## Relocated Pit Markers

## Weeden Pit #30 Markers

# M1993-087 / Weeden Pit No 30 / Baca County

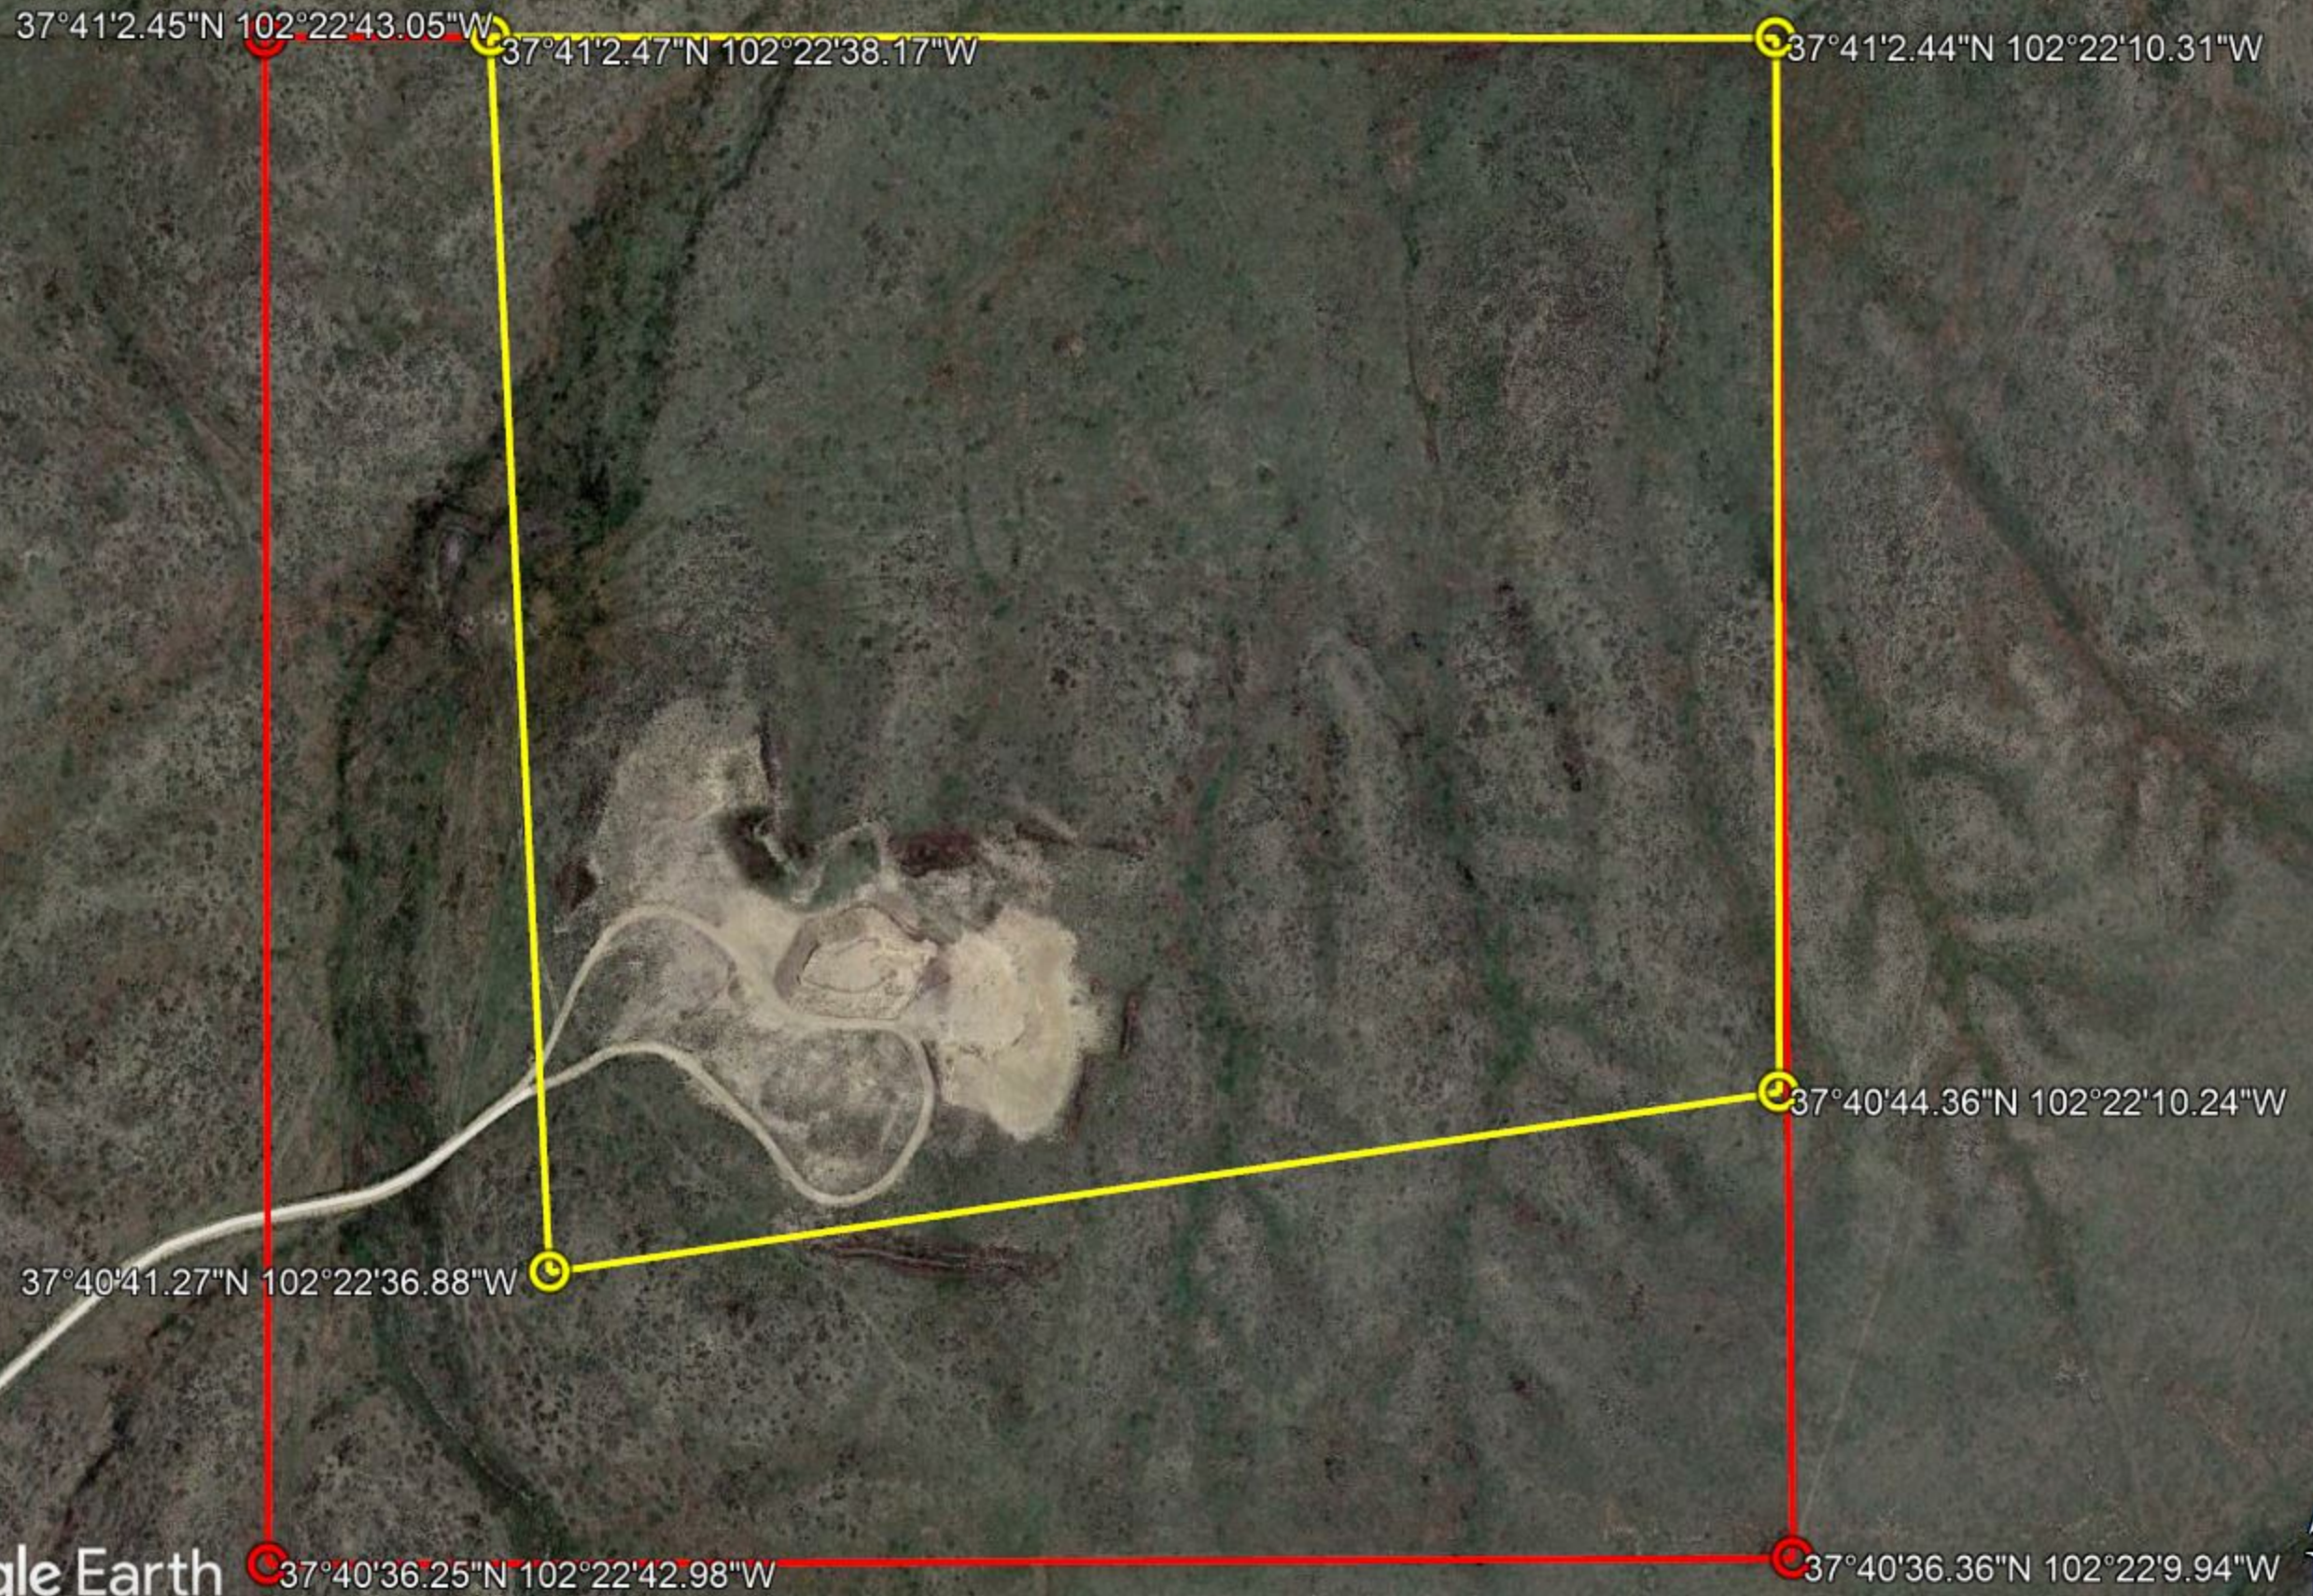
Please disregard the map I just sent because I just got your SE corner coordinates and plotted them in Google Earth too. The south boundary as marked by your existing markers is pretty whacky. Take a look - I'm attaching a revised map with all your coordinates now, and the marked permit area comes out to 100 acres (60 acres less than the approved 160 acres).

Red Outline = 160 acres = Approved Permit Area

Yellow Outline = 100 acres = Permit Area as delineated by existing markers

I appreciate you getting these coordinates and pics to me. I plotted them in Google Earth and found the marked permit area to be 109 acres, the western boundary is not quite straight, and the southern boundary sort of overlaps the topsoil pile (which is not good). To get the boundary marked correctly, it looks like you could move your NW corner marker due west 392 feet, and your SW corner marker 505 feet due south then 500 feet due west.

I'm attaching a Google Earth map showing the approved permit area compared to the permit area as delineated by the existing markers. The coordinates are on there too so you could use them as a guide when resetting your NW and SW markers.
